# CPED STAFF REPORT

Prepared for the Heritage Preservation Commission

HPC Agenda Item #1  
 August 19, 2014  
 BZH-28149

*Property Location:* 400 2<sup>nd</sup> Street Southeast  
*Project Name:* Pillsbury “A” Mill Machine Shop Rehabilitation  
*Prepared By:* [John Smoley](#), Ph.D., Senior City Planner, (612) 673-2830  
*Applicant:* Schaffer Richardson  
*Project Contact:* Amanda Janzen  
*Ward:* 3  
*Neighborhood:* Marcy Holmes  
*Request:* To rehabilitate the Pillsbury “A” Mill Machine Shop for a new office use  
*Required Applications:*

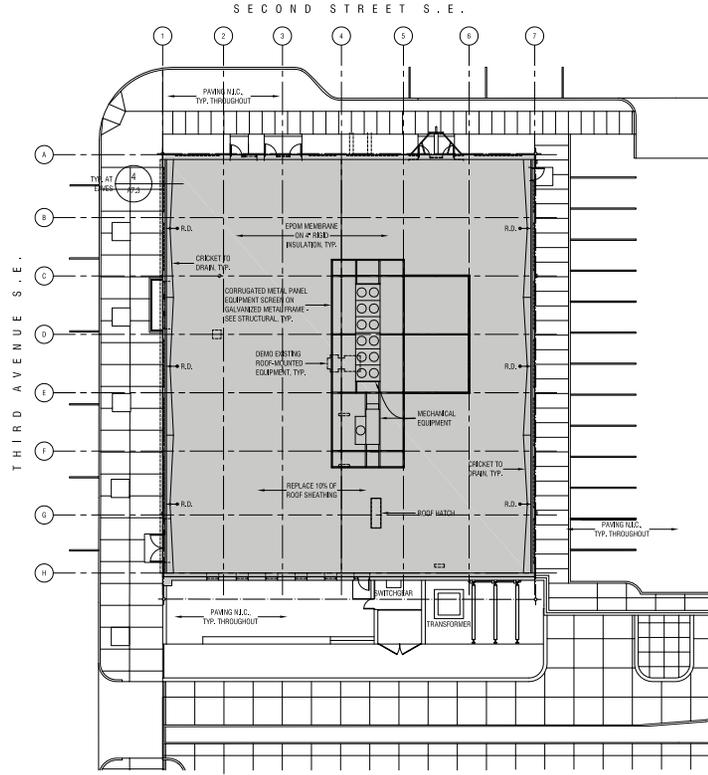
Schafer Richardson, as developer of the Machine Shop, is also seeking a variance to eliminate rooftop screening and transformer screening. The elimination of screening is desired in order to keep with the original, historic industrial nature of the building when all of the mechanical equipment was exposed. The request for the variance is also in response to NPS's condition to remove the screening.

The transformer is located south of the building between three supporting steel beams and the trash area. This provides indirect screening from 3rd Street and the entrance to the parking garage for the A-Mill complex. Additional screening in this area will conflict with the industrial appearance of the building and the area.

Rooftop equipment includes an air handler and fluid cooler for the building. Since we do not know the future tenants that will occupy the space, we have accommodated our mechanical capabilities for a possible restaurant. If a restaurant locates into the building, an additional air handler and ventilation exhausts will be located on the roof. Below are the dimensions of the rooftop equipment.

1. All mechanical equipment and supporting infrastructure (to include ductwork, lines, and safety guardrails) shall be painted a dark muted color and set back from the roof edge at least as far as the equipment projects above the roof deck, to minimize views of this new equipment not available during the district's period of significance from the public right-of-way.

2. Enclose transformer lines in conduit and paint the transformer and lines to match the existing background color (the new stucco wall to the rear, the A-Mill wall to the south, or some other background color, as verified by staff).

# Machine Shop Exterior Brick & Stone Replacement

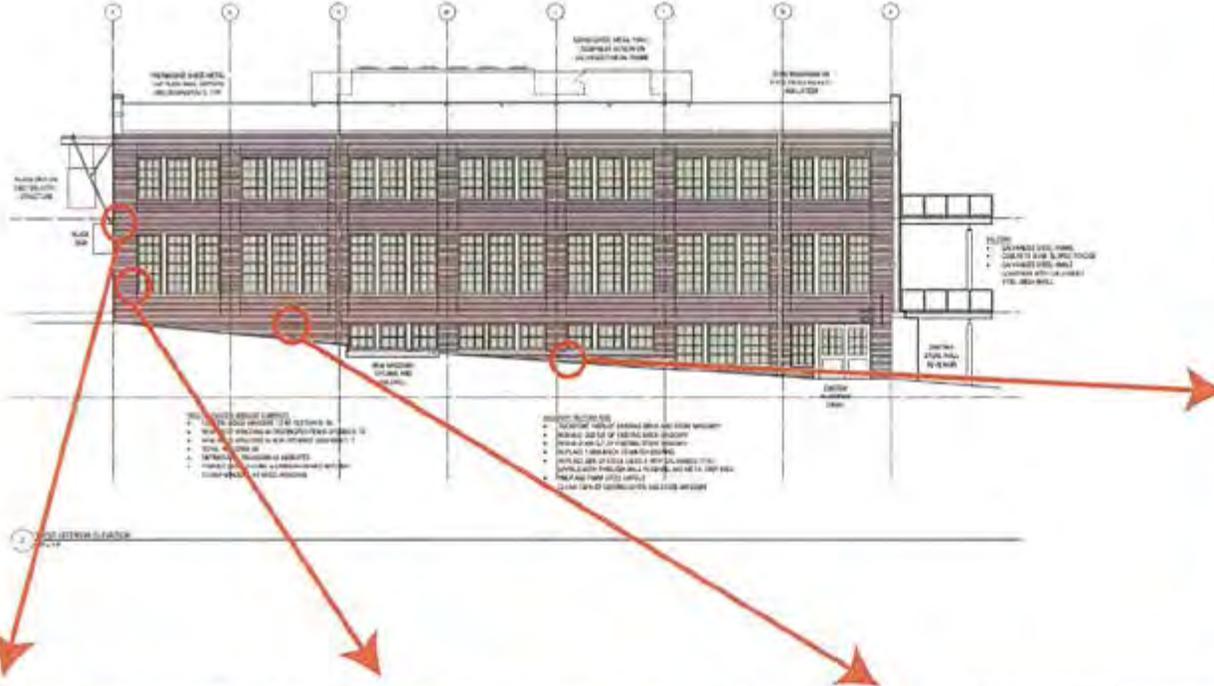
Damaged individual brick in field at random locations

50 % brick replacement at the base of the structure sidewalk is needed.

Delaminating brick at panels.

5. Masonry surfaces may be cleaned with low pressure water and detergents, using natural bristle brushes. Chemical masonry cleaner may be used to remove graffiti and mortar wash if the water and brushes fail to do so.

6. Hand-raking, not mechanical methods, shall be used to remove deteriorated mortar on vertical joints to avoid damaging the masonry.
7. All historic and nonhistoric windows and doors shall be painted to match each other.

D2

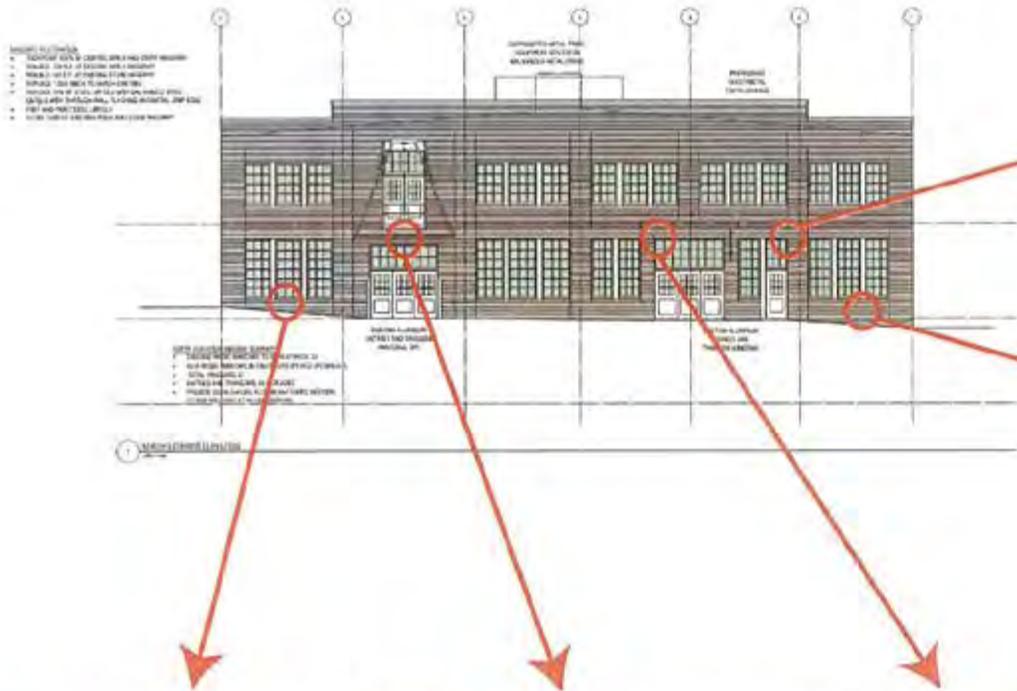
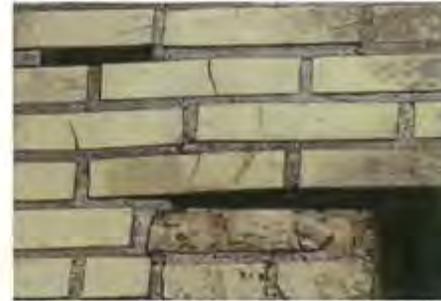
Brick over lintels delaminating and will be replaced with new brick to match.

Typical field of delaminating brick masonry at base of building

Typical delaminating rowlock sills.

Cracked brick at expanding lintels to be replaced.

D3

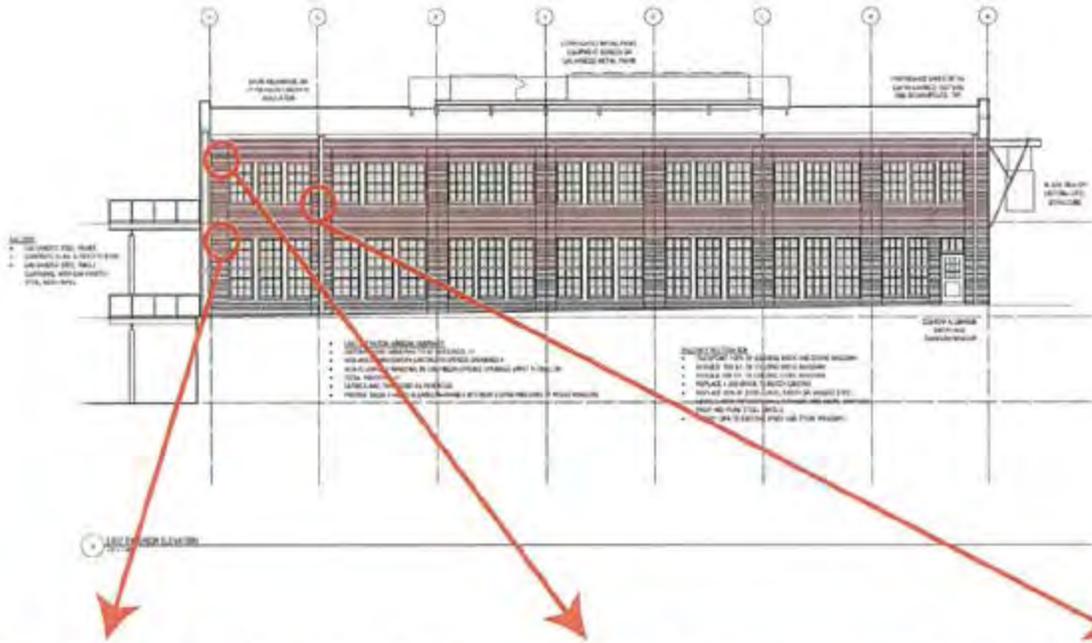
Typical delaminated brick in field  
Random locations.

Column to require large field of brick replacement.

D4

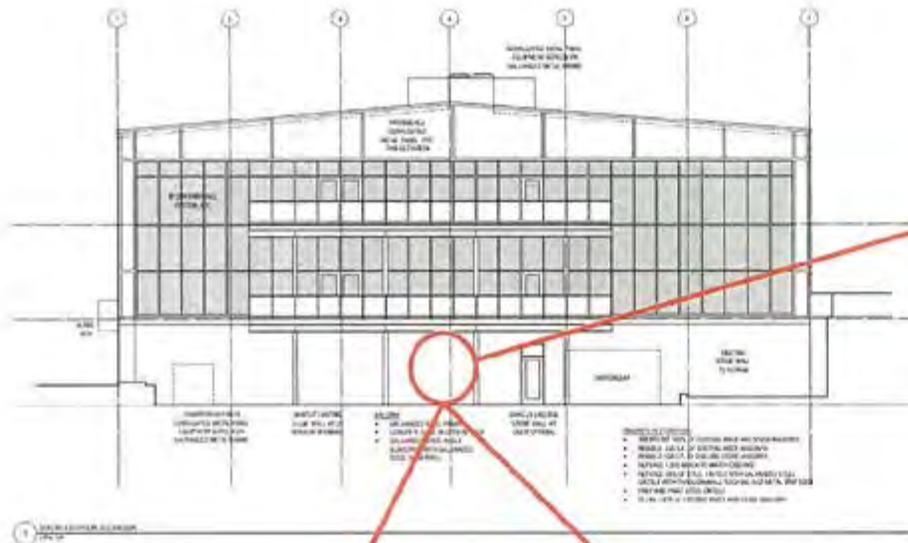
Missing stone sections.

**WINDOW 009 - Indicated to be replaced**

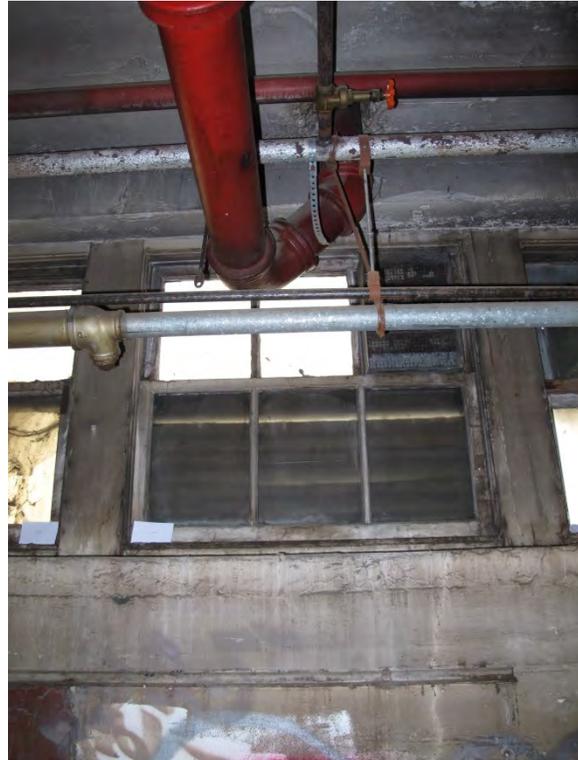
Frame and sash show rot at exterior. Wood louvers have been added at exterior of lower sash. Upper sash modified for mechanical penetrations.

9. Prior to the issuance of building permits for window repair and replacement, the applicant shall submit plans demonstrating that the replacement window profiles, installation depths, and component dimensions match those of the existing historic windows.

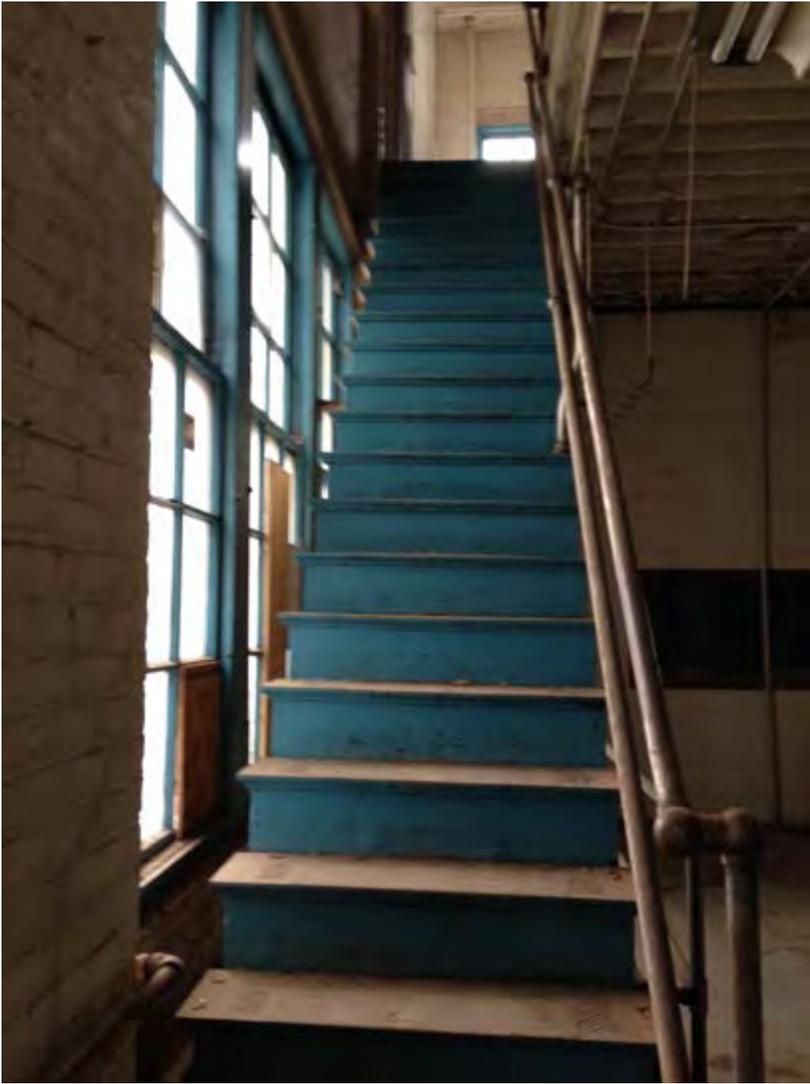
South wall to be removed and replaced with glass and aluminum curtainwall.

- 1). Cladding on the South Elevation must be compatible in material and design to the historic building and the historic district. The existing cladding may be retained, or, if replaced, it must be a masonry wall (brick or stucco). Plans must be revised and approved by SHPO and NPS prior to construction.
